Licence Number L6786/1991/11

Licence Holder Water Corporation

Albany Wastewater Treatment Plant
100 Timewell Road
MCKAIL WA 6330; and
35790 Albany Highway (Access via Gunn Road)
DROME WA 6330

Amendment

Schedule 1: Premises map - Timewell Road Wastewater Treatment Plant

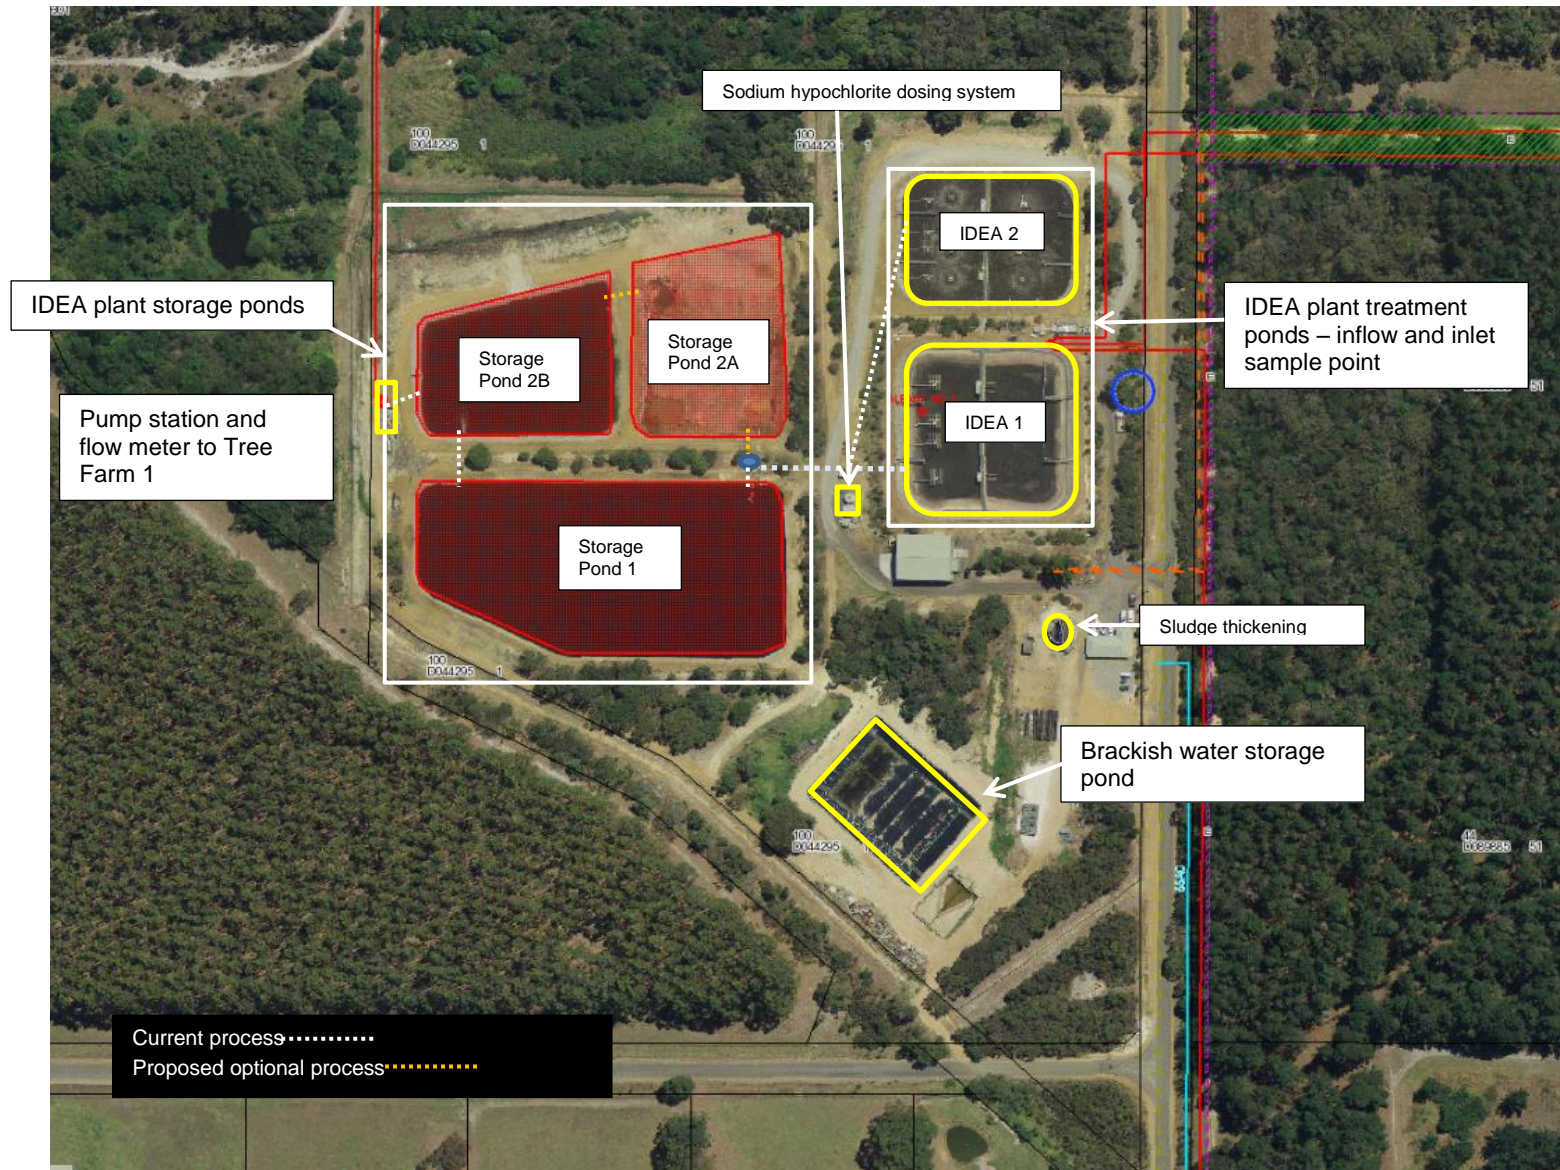
The process flow change will allow discharge from the IDEA plant to storage ponds by altering the flow from the IDEA plant and subsequent transfer to Tree Farm 1 by:

Indicating treated wastewater from the idea plant may be alternated between storage pond 1 or pond 2A and subsequent transfer from pond 2B or pond 1 (See Schedule 1 Premises map).

3. Schedule 1 Premises Map is amended to reflect updated naming conventions for the 'Timewell Road WWTP' and 'Tree Farm 1 – septage plant' by the removal of the old maps and insertion of the following maps:
